**MAYFAIR 2<sup>ND</sup> ADDITION REPLAT 5**

RECOMMENDATION REPORT

CASE NUMBER: 2012-SUP-01

RE: Application for Replat-Initial Review  
Mayfair 2<sup>nd</sup> Addition Replat Five

# MAYFAIR 2nd ADDITION REPLAT FIVE

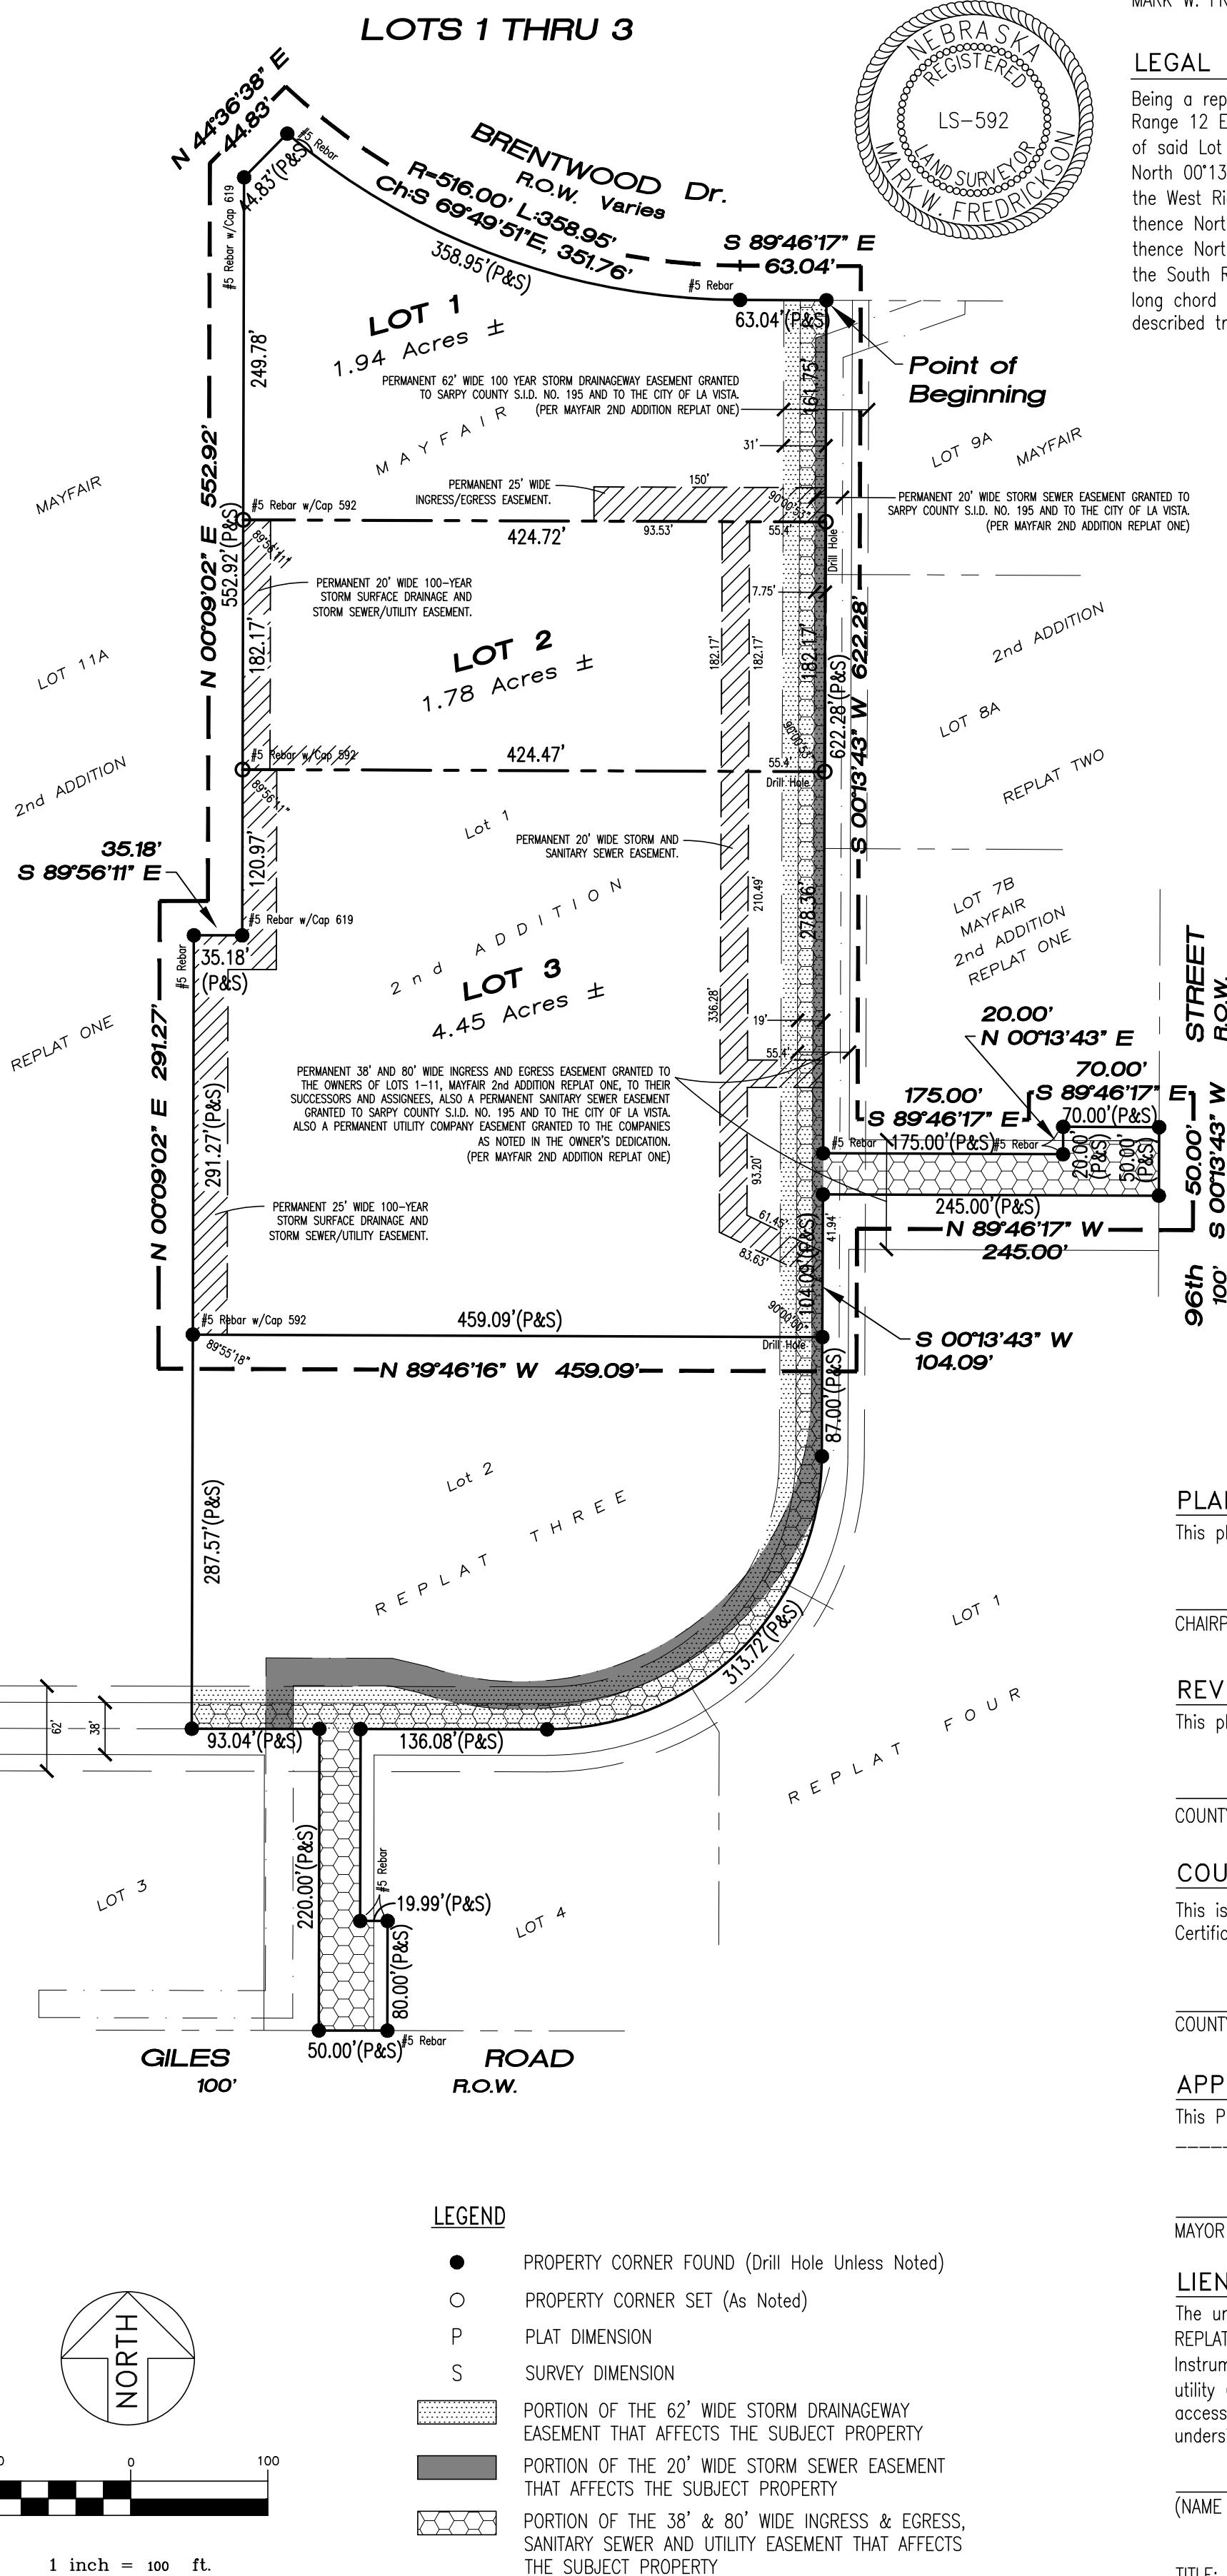
10. The final plat needs to address provision of easement rights for utility companies to serve the lots by notation or illustration or addition of language to the dedication.

11. The adjacent subdivision names to the west, north and east of the property need to be added.
12. Identify the range in width of Brentwood Drive right of way adjacent to Lot 1 by adding to the note "R.O.W. Varies".
13. Identify the dimension of the common lot lines between Lots 1, 2 and 3.
14. A major storm, storm sewer and utility easement is indicated along the west sides of Lot 2 and 3. Identify how this easement continues to the south. Provide a copy of an existing easement, if it exists.
